# UNITED STATES PATENT AND TRADEMARK OFFICE

APPLICATION NO.	FILING DATE	FIRST NAMED INVENTOR	ATTORNEY DOCKET NO.	CONFIRMATION NO.
10/575,318	04/11/2006	Gregory G. Brucker	CV/03-014	3785

<b>Office Action Summary</b>	<b>Application No.</b> 10/575,318	<b>Applicant(s)</b> BRUCKER ET AL.	
	<b>Examiner</b> KAMI A. BOSWORTH	<b>Art Unit</b> 3767

## **DETAILED ACTION**

Fig. A

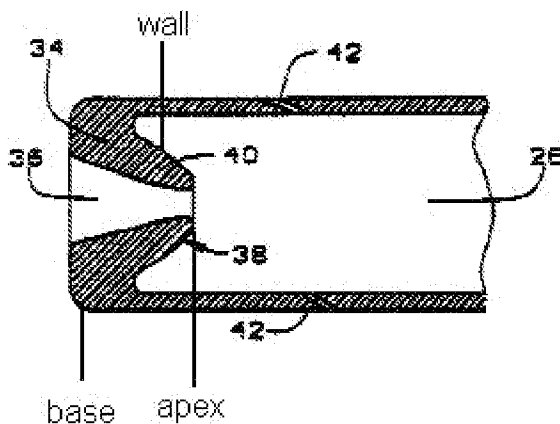
distally as pressure of the fluid within said restrictor increases (Col 14, Lines 63-66) for the purpose of limiting flow out of the valve (Col 14, Lines 66-67). Therefore, it would have been obvious to one of ordinary skill in the art at the time of the invention to modify Lindsay to include a conically-shaped valve that generally decreases a size of an opening as pressure increases, as taught by Stevens et al., for the purpose of limiting flow out of the valve (Col 14, Lines 66-67).

27. Re claim 8, Lindsay discloses that said conically-shaped valve includes a circular base portion (best seen in Fig A above) affixed to approximately a distal end of said tip; and a conical wall portion 38 (best seen in Fig A above) extending and decreasing in thickness (as seen in Fig 6) from said circular base portion to said apex.

41. Re claim 52, Lindsay discloses that said conically-shaped valve includes: a circular base portion (best seen in Fig A above) affixed to approximately a distal end of

said tip; and a conical wall portion (best seen in Fig A above) extending and decreasing in thickness (as seen in Fig 6) from said circular base portion to said apex.

Fig. B

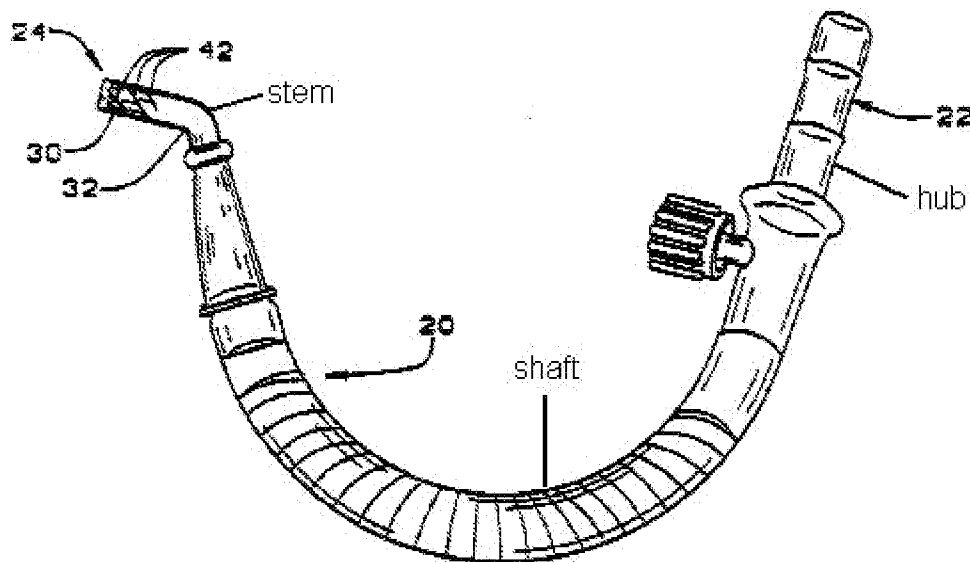
20. Re claim 1, Lindsay discloses a catheter assembly 20 (Fig 1) for introducing fluid into a vessel (Col 1, Lines 10-12), the catheter assembly comprising: a shaft (best seen in Fig B below); a hub 28 (Col 2, Line 37) affixed to a proximal end of said shaft; a stem 30 (Fig 1) affixed to a distal end of said shaft, said stem having a porous section (defined by microholes 42, Fig 1) approximate a distal end thereof, said porous section defining a plurality of microholes 42 (Fig 1) generally distributed uniformly thereabout and inclined by a predetermined angle (Col 3, Lines 8-9) in a proximal direction; and a tip 34 (Fig 6) affixed to said distal end of said stem, said tip including a conically-shaped valve 40 (Fig 6) with an apex (best seen in Fig A above) thereof defining an opening 36 (Fig 6) and pointing in the proximal direction (as seen in Fig 6) such that as the fluid flow within said catheter assembly and pressure increases within said tip, said conically-shaped valve dynamically changes (Col 3, Line 48-50) and the amount of the fluid flowing out of said microholes of said stem increases (Col 3, Lines 48-53). Lindsay does not disclose that said conically-shaped valve generally decreases a size of said opening so that the amount of the fluid flowing out of said opening of said tip decreases; nor does Lindsay disclose that the forces of the fluid flowing out of said microholes and said opening substantially balance thereby enabling a position of said tip and said stem within the vessel to remain stable while fluid is finely dispersed therefrom.

61. Re claim 60, Lindsay discloses a shaft (best seen in Fig B above) affixed to a proximal end of the stem and a hub 28 (Col 2, Line 37) but does not disclose a strain relief element affixed to the proximal end of the shaft and to the distal end of the hub. Klima et al., however, teaches a strain relief element 22 (Fig 1) interconnected between a hub 16 (Fig 1) and a proximal end of a shaft 20 (Fig 1) for the purpose of providing a connection between the hub and the shaft (Col 2, Line 47). Therefore, it would have been obvious to one of ordinary skill in the art at the time of the invention to modify Lindsay/Stevens et al./Savage et al. to include a strain relief element, as taught by Klima et al., for the purpose of connecting the hub and shaft (Col 2, Line 47).

Fig. C

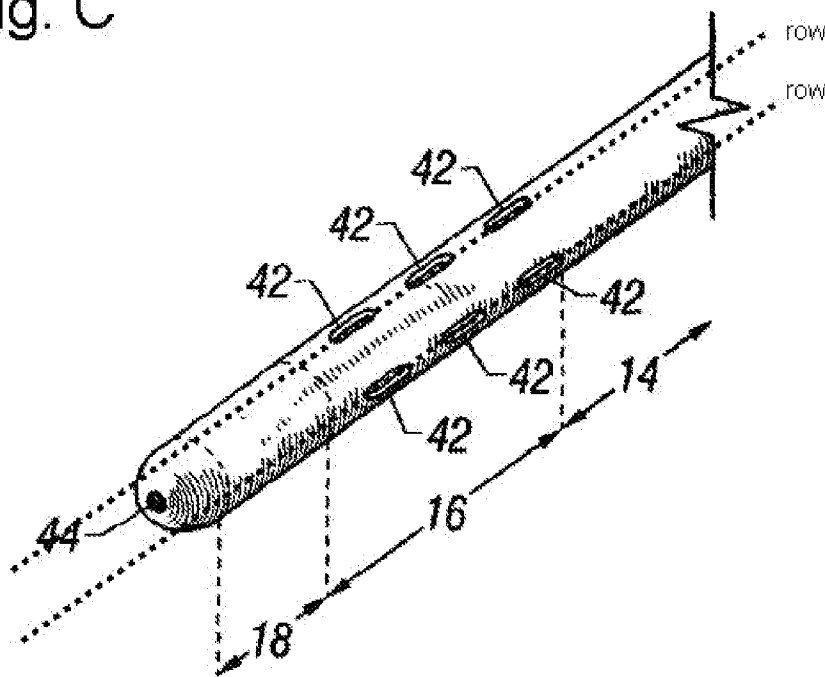
37. Re claims 22 and 32, Lindsay/Stevens et al. disclose all the claimed features except that microholes are distributed about said porous section according to a pattern having a plurality of pairs of longitudinally arranged rows, with each of said rows being laterally spaced generally equidistantly from its neighbors. Savage et al., however, teaches that microholes 42 (Fig 2) are distributed about said porous section according to a pattern having a plurality of pairs of longitudinally arranged rows (best seen in Fig C below) with each of said row pairs being laterally spaced generally equidistantly from its neighbors (as seen in Fig C below; Page 12, Lines 3-4) for the purpose of ensuring a

substantial cancellation of the fluid force vectors (Page 11, Lines 5-7). Therefore, it would have been obvious to one of ordinary skill in the art at the time of the invention to modify Lindsay/Stevens et al. to include microholes arranged into a plurality of pairs of longitudinally arranged rows spaced equidistantly from each other, as taught by Savage et al., for the purpose of ensuring a substantial cancellation of the fluid force vectors (Page 11, Lines 5-7).

having a plurality of pairs of longitudinally arranged rows (best seen in Fig C above) with each of said row pairs being laterally spaced generally equidistantly from its neighbors (as seen in Fig C above; Page 12, Lines 3-4) for the purpose of ensuring a substantial cancellation of the fluid force vectors (Page 11, Lines 5-7). Therefore, it would have been obvious to one of ordinary skill in the art at the time of the invention to modify Lindsay/Stevens et al. to include microholes arranged into a plurality of pairs of longitudinally arranged rows spaced equidistantly from each other, as taught by Savage et al., for the purpose of ensuring a substantial cancellation of the fluid force vectors (Page 11, Lines 5-7).

Fig. D

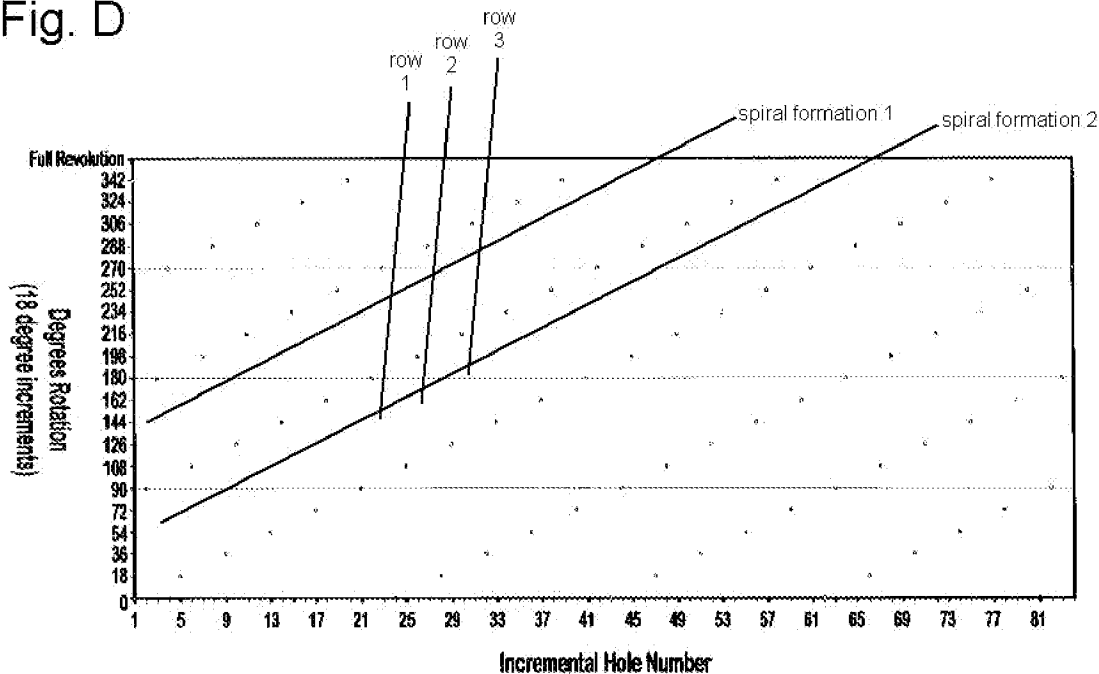
65. Re claim 75, Lindsay/Stevens et al./Savage et al. disclose all the claimed features except that the porous section has two of said spiral formations each of which having a plurality of laterally-offset rows of microholes, with each of said rows in one of said spiral formations being diametrically opposite from a counterpart one of said rows in the other of said spiral formations. Mottola et al., however, teaches that the porous section (formed by microholes 34, Fig 3) has two of said spiral formations (best seen in Fig D below; Col 3, Line 39) each of which having a plurality of laterally-offset rows of microholes (best seen in Fig D below) for the purpose of creating a complete dispersion of fluid (Col 3, Line 40). Mottola et al. does not explicitly teach that each of said rows in one of said spiral formations being diametrically opposite from a counterpart one of said rows in the other of said spiral formation but does teaches that the angles of spacing and inclination between holes can be modified (Col 4, Lines 42-64); a change in such angles could produce rows that are diametrically opposite from a counterpart row in the second spiral formation for the purpose of creating a complete dispersion of fluid (Col 3, Line 40). Therefore, it would have been obvious to one of ordinary skill in the art at the time of the invention to modify Lindsay/Stevens et al./Savage et al. to include two spiral formations having a plurality of laterally-offset row of microholes, as taught by Mottola et

al., for the purpose of creating a complete dispersion of fluid (Col 3, Line 40).

Fig. E

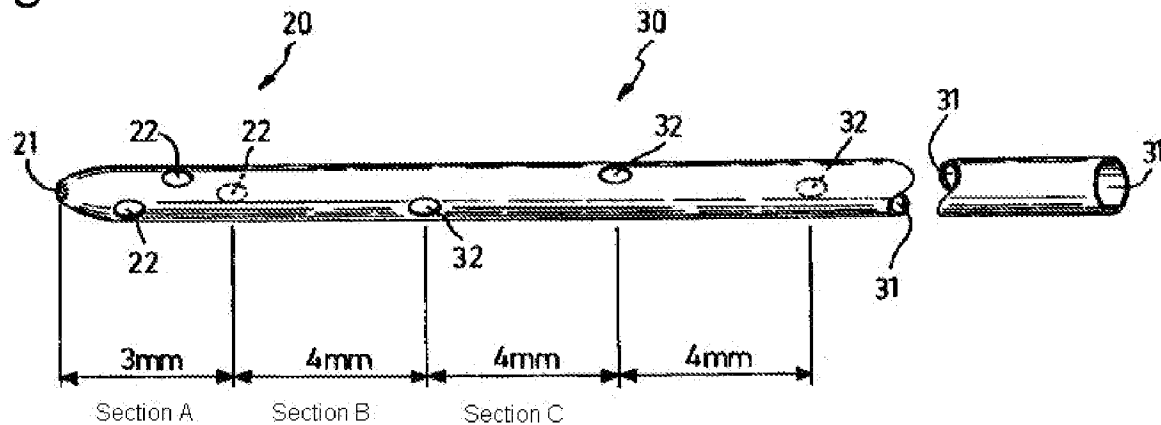
69. Re claim 34, Lindsay/Stevens et al./Savage et al./Mottola et al. disclose all the claimed features except that the microholes along the longitudinal axis are deployed in a plurality of sections of substantially equal length wherein the number of said microholes in each of said sections changes according to a linear progression. Eldor, however, teaches that the number of microholes 22, 32 (Fig 1) along the longitudinal axis are deployed in a plurality of sections A, B (best seen in Fig E below) of substantially equal length (as seen in Fig E below) wherein the number of said microholes in each of said sections changes according to a linear progression (1 microhole in section B, 3 microholes in section A as in Fig E below) for the purpose of injecting a desired stream of fluid (Col 4, Lines 49-50). Therefore, it would have been obvious to one of ordinary skill in the art at the time of the invention to modify Lindsay/Stevens et al./Savage et al./Mottola et al. to include microholes deployed in a plurality of sections having substantially equal length wherein the number of said microholes in each section changes according to a linear progression, as taught by

Eldor, for the purpose of injecting a desired stream of fluid (Col 4, Lines 49-50).
